Antelope Valley Public Landfill (AVPL)

Finding of Conformance (FOC)

County of Los Angeles Dept. of Public Works
Environmental Programs Division

Off-Site Structures Within 1,000 Feet of Permitted Waste Limit

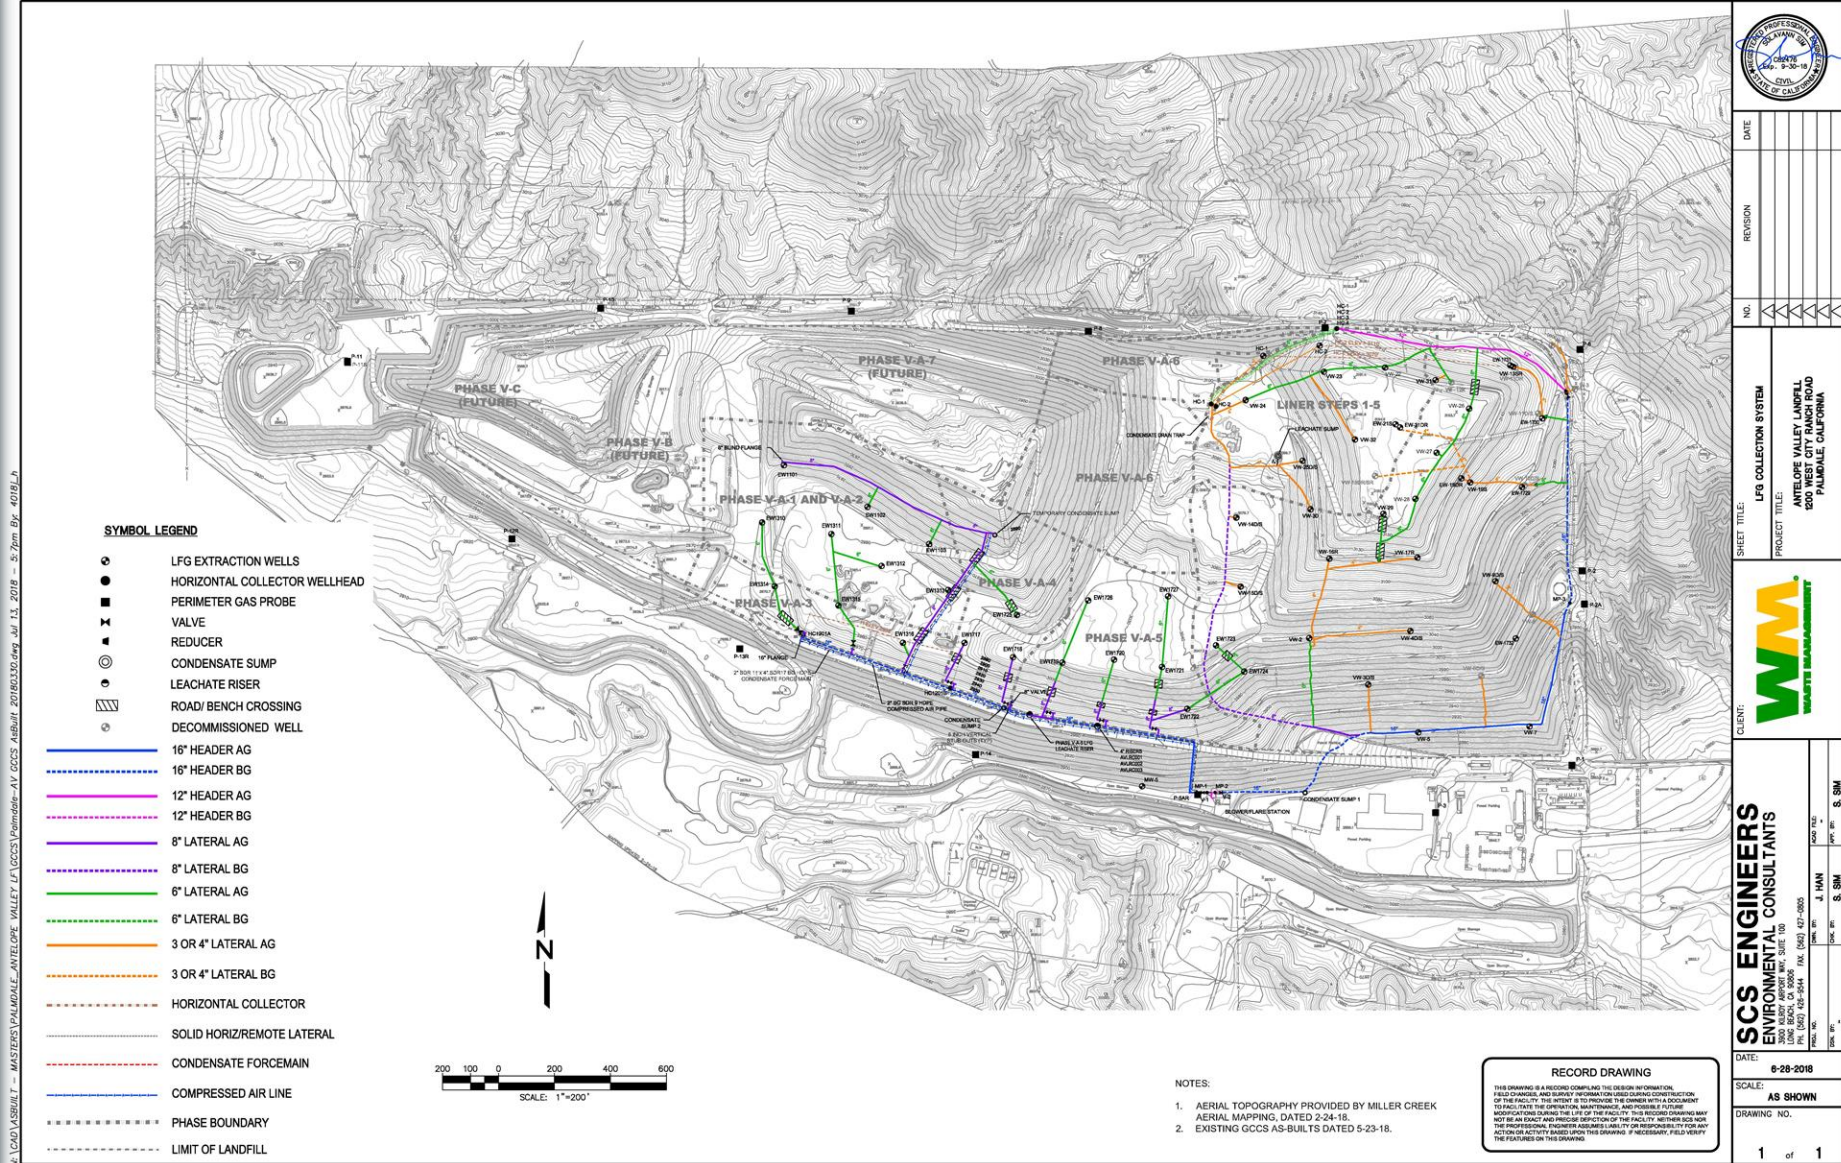
- ❑ The proposal is also consistent with Objective L6.2.2 of the City of Palmdale General Land Use
 - ❑ Policy L6.2.2: Provide a 1,000 foot buffer between property designated as PF-Landfill on the General Plan Land Use Map and future residential developments.
- ❑ The existing off-site structures within 1,000 feet of the permitted limit of waste are: SCE Substation and a 1-Story Industrial Bldg.
- ❑ There are no proposed structures/projects located within 1,000 feet of the permitted waste limit.

To protect the on-site existing structures and those within 1,000 ft of the landfill footprint against subsurface landfill gas migration, Condition 85 of the CUP has provisions to protect these facilities.
